VNI West Project Assessment Conclusions Report Volume 2: Additional Consultation Report Submissions

May 2023

Regulatory Investment Test for
Transmission

Figure 10 Gippsland REZ transmission – available and post Latrobe Valley (LV) coal closure (Step Change) - Additional Consultation Report market modelling outcomes

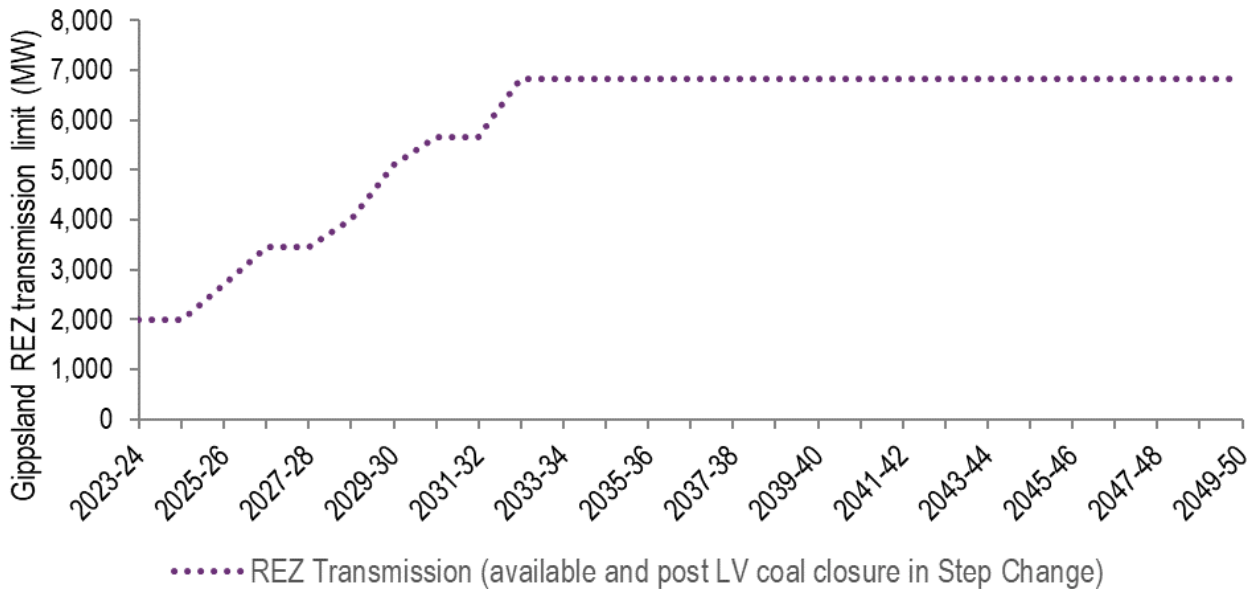
Transmission constraints applied to represent the transmission network limitations out of the Gippsland REZ account for an increase in transmission capacity with closure of Latrobe Valley coal-fired generation. The spare network capacity for the Gippsland REZ today is estimated to be approximately 2,000 MW, and this progressively increases over time as coal-fired generation in Latrobe Valley closes. Once all coal-fired generation has closed in Victoria (assumed to be from 2032 in the *Step Change* scenario based on ISP market modelling), the spare network capacity assumed in the Additional Consultation Report modelling has increased to around 6,800 MW at no cost, as shown in Figure 10. This is obviously contrary to p.10 of the submission, which claimed a blanket 2,000 MW transmission limit was applied.

Further increases in capacity beyond those shown in Figure 10 would require transmission augmentation. This is allowed in the modelling at an additional cost, measured in \$m/MW, which has been derived and consulted on as part of the ISP process through assessment of the likely cost and transmission capacity increase from potential line augmentations to locations where there is generator connection interest. The value of the REZ expansion cost applied to the Gippsland REZ is the lowest of the expansion costs applied to any REZ in Victoria, and lower than many other REZs in the NEM. The expansion cost reflects the current cost of building additional transmission capacity and is essentially the equivalent of the ‘low cost’ additional capacity cost in the submission. The submission claimed this is a steep penalty being applied beyond 2,000 MW. In fact, the cost applied beyond the 2,000 MW is the cost of expanding transmission capacity from the Gippsland REZ, and not a steep penalty as claimed.

Figure 12 Renewable build in Gippsland REZ, Option 5, Step Change, offshore wind sensitivity – Additional Consultation Report market modelling

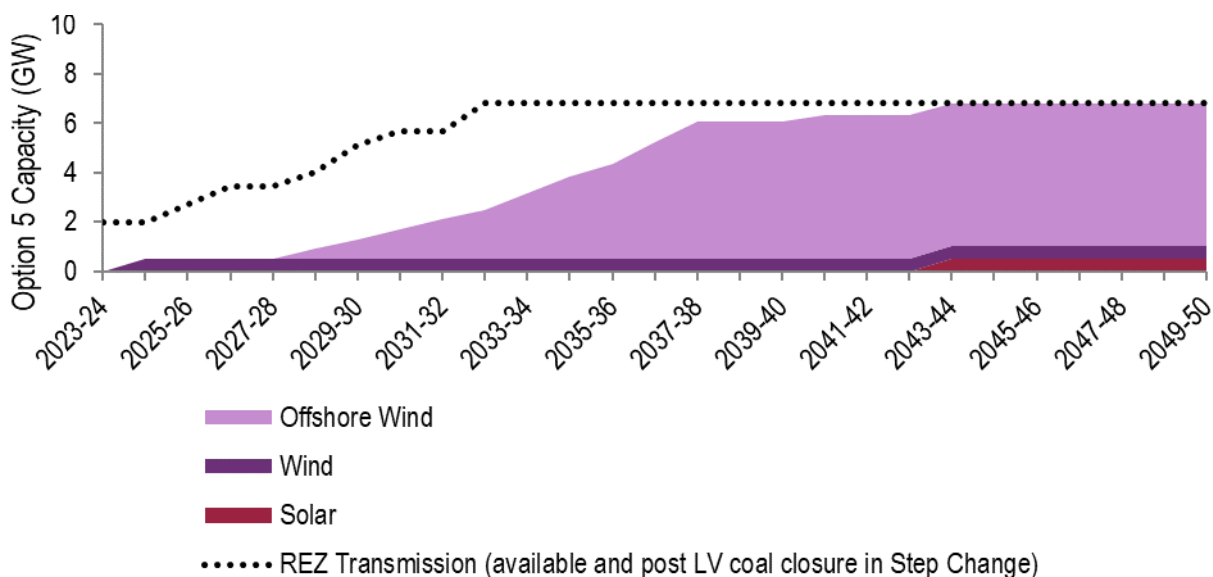
Even if the onshore wind and solar resource limits were underestimated, as suggested by VEPC, the offshore wind sensitivity shows that additional investment is required across Victoria, even once the existing Latrobe Valley network is well utilised, to meet the growing demand not only in Victoria, but also NEM-wide at the lowest cost, and that VNI West is forecast to continue to deliver significant net market benefits in this sensitivity.

The offshore wind sensitivity undertaken as part of the Additional Consultation Report, and again in this PACR, forecasts that the spare transmission capacity made available as coal-fired generation retires in the Latrobe Valley is fully utilised by a combination of both onshore (wind and solar) and offshore wind developments (see Figure 12). VNI West is forecast to continue delivering significant net market benefits under this sensitivity, helping harness additional renewable generation and also provide export opportunities for Victorian generators when output from wind and solar farms is surplus to the state’s requirements.

Note: In the base case for this sensitivity, the transmission capacity is also fully utilised and the combined onshore wind, offshore wind and solar capacity forecast to be built in Gippsland exceeds the REZ transmission limit.

Figure 21 Gippsland REZ and Murray River REZ normalised solar generation and Victorian demand on time of day average in 2035-36

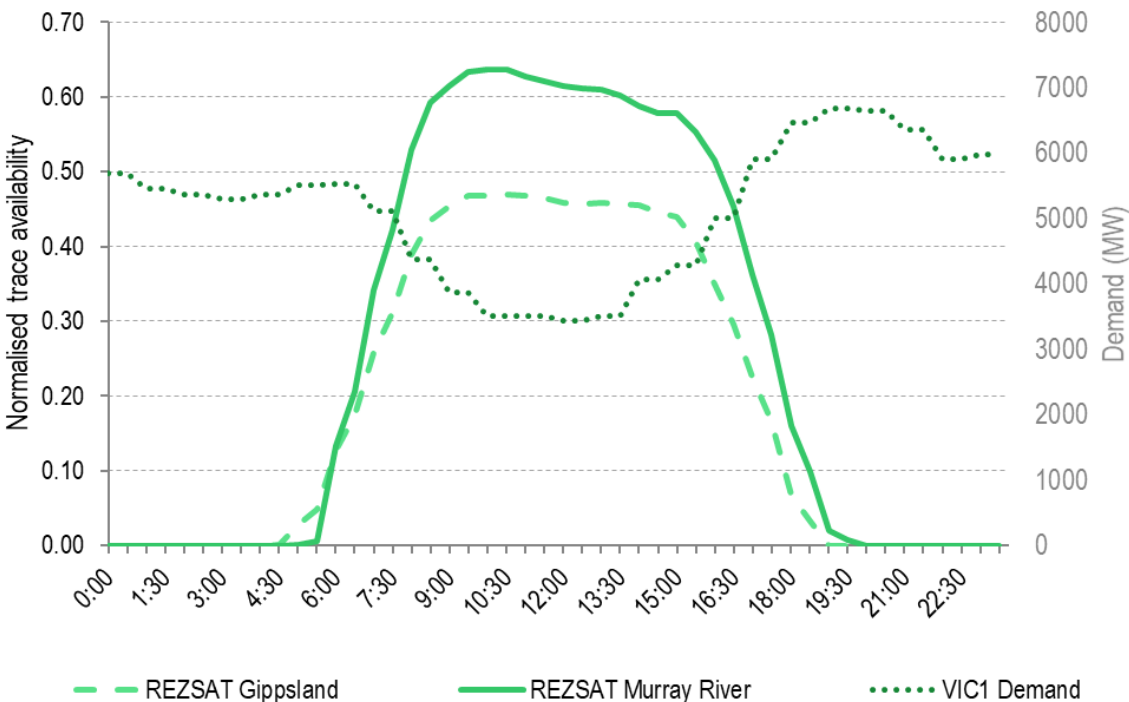
The claim that there are no systematic variations in solar or wind generation between regions of Victoria (p.22) appears to be based on a high-level view of coincidence and not on detailed analysis of similar calibre as that implemented in the VNI West RIT-T.

Murray River REZ is favourable for development based on average costs. Furthermore, there is a difference in the daily profile of available energy that favours solar generation from Murray River over Gippsland REZ. This is demonstrated in Figure 21, which shows average daily profiles of available solar generation in the Gippsland and Murray River REZs, as well as Victorian demand, in a sample 2035-36 year. It highlights that Murray River REZ solar generation helps supply the demand in the region in early evening, while Gippsland REZ solar ramps down just before Victorian demand begins to ramp up in the evening.
